PECOS DISTRICT CONDITIONS OF APPROVAL

OPERATOR'S NAME:	OXY USA Inc.
LEASE NO.:	NM104730
WELL NAME & NO.:	Sundance 4 Federal # 32
SURFACE HOLE FOOTAGE:	660' FNL & 458' FWL
BOTTOM HOLE FOOTAGE:	Same
LOCATION:	Section 4, T. 24 S., R 31 E., NMPM
COUNTY:	Eddy County, New Mexico

Cross Section of a Typical Lead-off Ditch

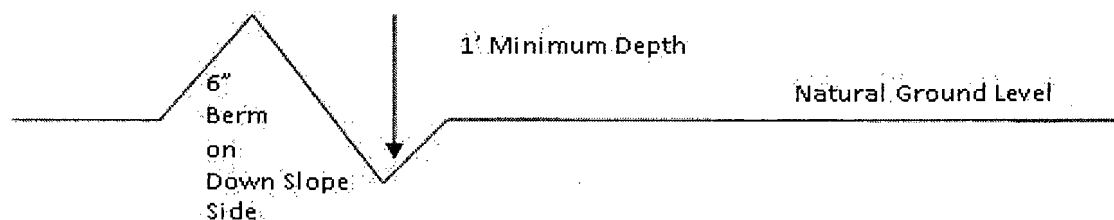
A typical lead-off ditch has a minimum depth of 1 foot below and a berm of 6 inches above natural ground level. The berm shall be on the down-slope side of the lead-off ditch.

Figure 1 – Cross Sections and Plans For Typical Road Sections

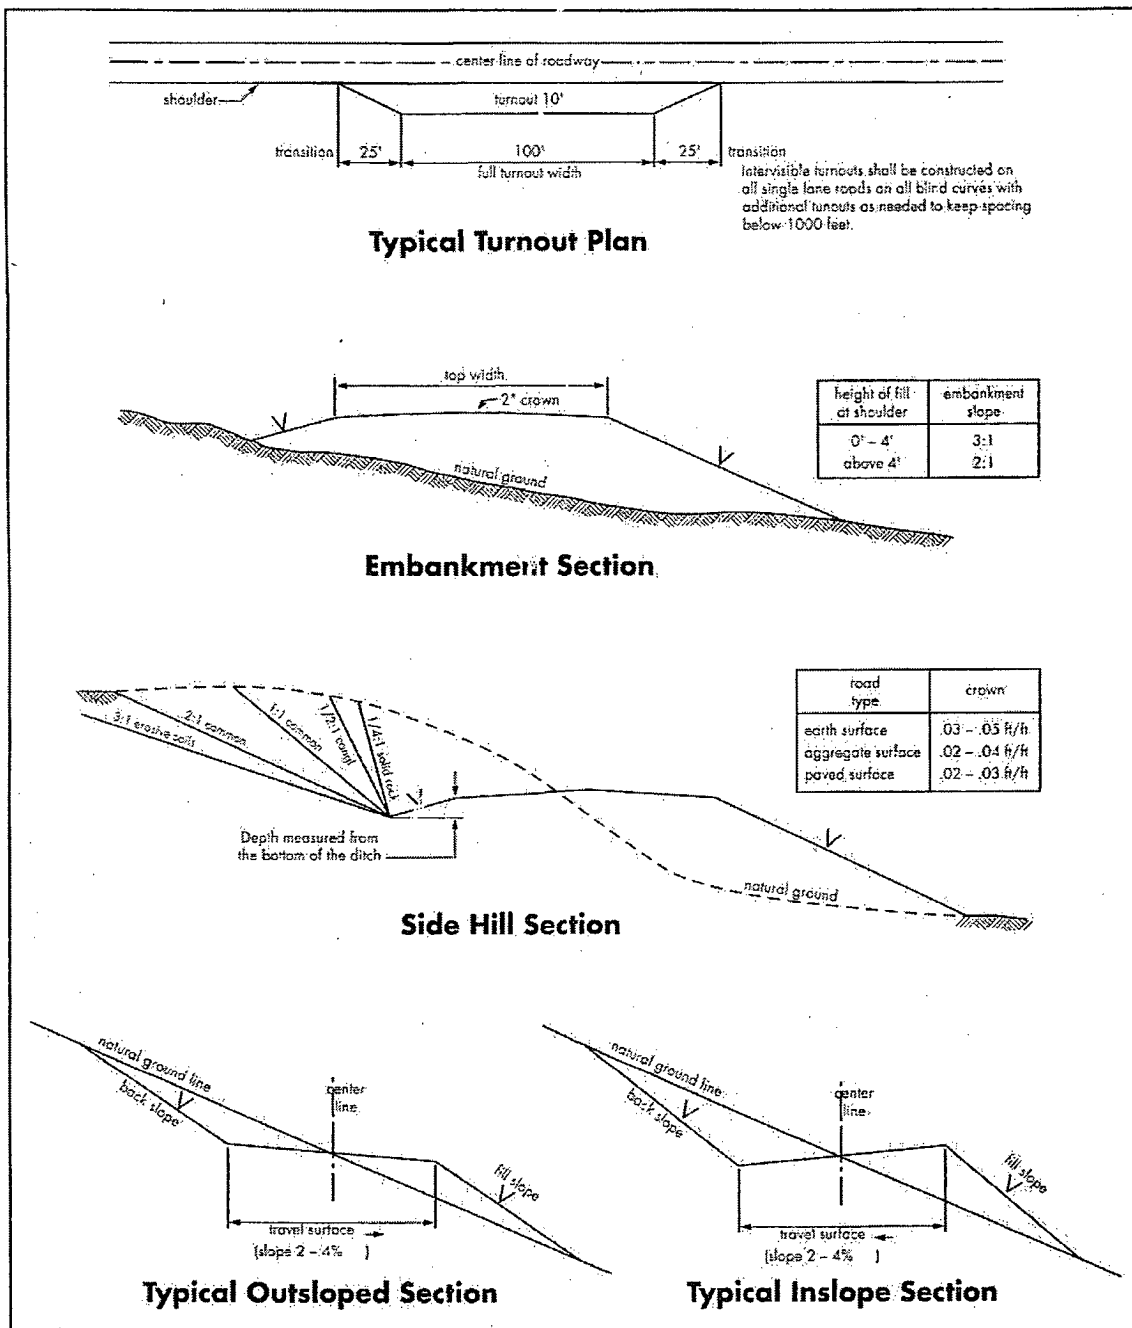
Crowning shall be done on the access road driving surface. The road crown shall have a grade of approximately 2% (i.e., a 1" crown on a 14' wide road). The road shall conform to Figure 1; cross section and plans for typical road construction.
